**RE: New Tweed Valley Hospital – Stage 2 (SSD\_9575) Tweed LGA**

## **Attachment 1: Detailed BCD Comments – New Tweed Valley Hospital – Stage 2 (SSD18\_9575)**

### Figure 1. Engineering details for the bio-detention basins

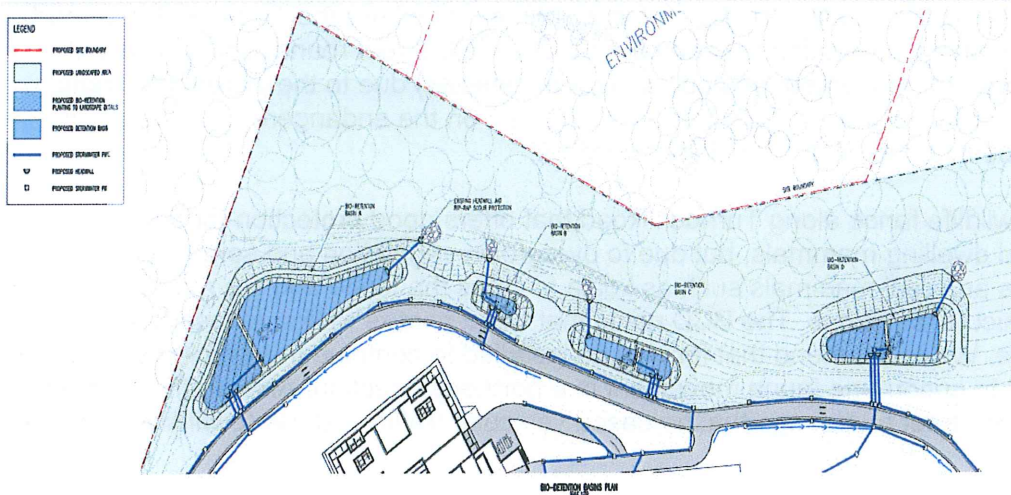
New plantings in the sediment basins were proposed to both treat stormwater quality and contribute to providing a range of native habitat or 'moist corridors' across the site. The BCD notes that only portions of the future bio-detention basins will have planted sections as described in Figure 1 and, as the liners will be perforated, there will be no standing water. This reduces the potential habitat that could be established here. There is no discussion on why the planted areas are so limited in the bio-detention basin areas.

- a. Greater effort should be given to reducing the stormwater volumes entering the basins such as including more storage and reuse of runoff and more use of swales and raingardens in suitable locations.

- b. The recommendations outlined in the SMEC report for refinements to the basin outflow design and for greater channel infiltration to ensure stormwater discharge is managed to reduce impacts on the wetland should be incorporated into final engineering designs and documentation.

**Figure 2 Flight path map from Avipro report and Figure 3 BDAR Appendix I showing two flying-fox camps in the vicinity of the hospital site.**

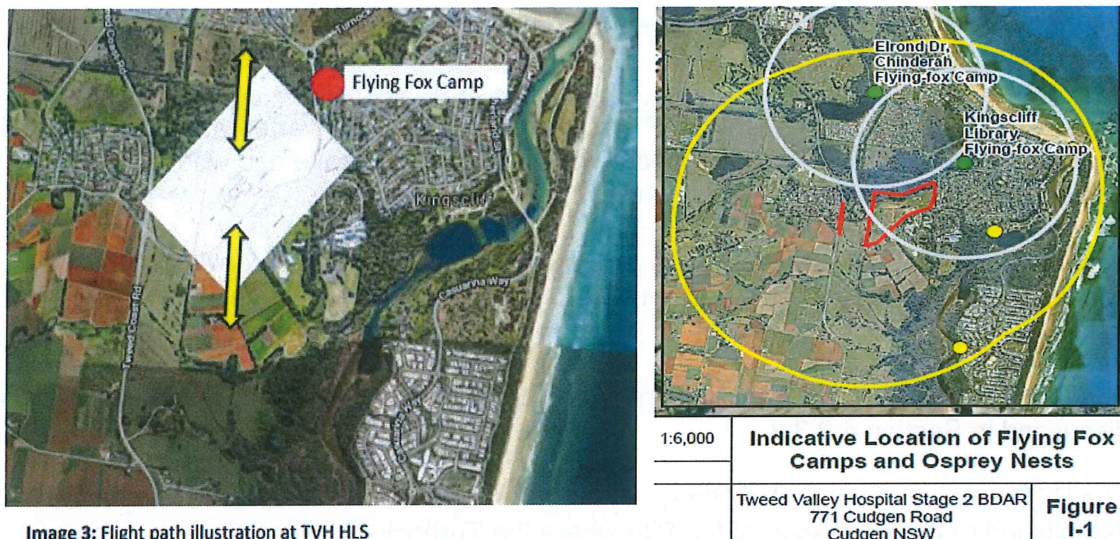
The Avipro report includes a map of the probable flight path, which only considers one flying-fox camp. The report states the preferred and safest approach and departure directions are north-south and this avoids sensitive areas such as the one known area of significant biodiversity interest (flying-fox camp). It does not identify another flying-fox camp located approximately 1.3 kms north of the site which is known as the Elrond Drive, Chinderah camp as identified in the Tweed Flying-fox Camp Management Plan by Ecosure dated March 2018 and Appendix I of the BDAR (see Figures 2 and 3).

The Avipro report states that nearer to HLS commissioning, helicopter operators will be apprised of the exact location of the flying fox camp and procedures will be developed in consultation to provide maximum clearance on each occasion a HEMS helicopter approaches or departs the hospital. The details on how this information will be developed and who will be consulted is not provided. The Avipro report also states that the location of the sensitive areas may be advised to ASA for possible inclusion in relevant publications, but again does not describe who will provide this advice and does not make it a requirement.

The BCD recommends that the Elrond Drive, Chinderah flying-fox camp and any other potential locations for flying-fox camps, as identified through discussions with the Tweed Shire Council and local wildlife carer organisations managing flying-foxes, be considered to ensure that any risks arising from the helicopter operations are addressed.

- a. Revise the Avipro report to consider other potential locations for flying-fox camps, as identified in the Tweed and through discussions with Tweed Shire Council and any wildlife carer organisations operating in the region, such as the Elrond Drive, Chinderah flying-fox camp, be thoroughly investigated to ensure that if present the risks to these camps will also be a consideration for the helicopter operations.
- b. Require an Aviation Operations Manual to be prepared that includes:
  - i. measures to reduce bird strike (including bats),
  - ii. prescriptions for planned approach and departure paths to the HLS that minimise impacts on environmentally sensitive areas, and
  - iii. a requirement for documentation of all native fauna injuries and deaths in an incident register.
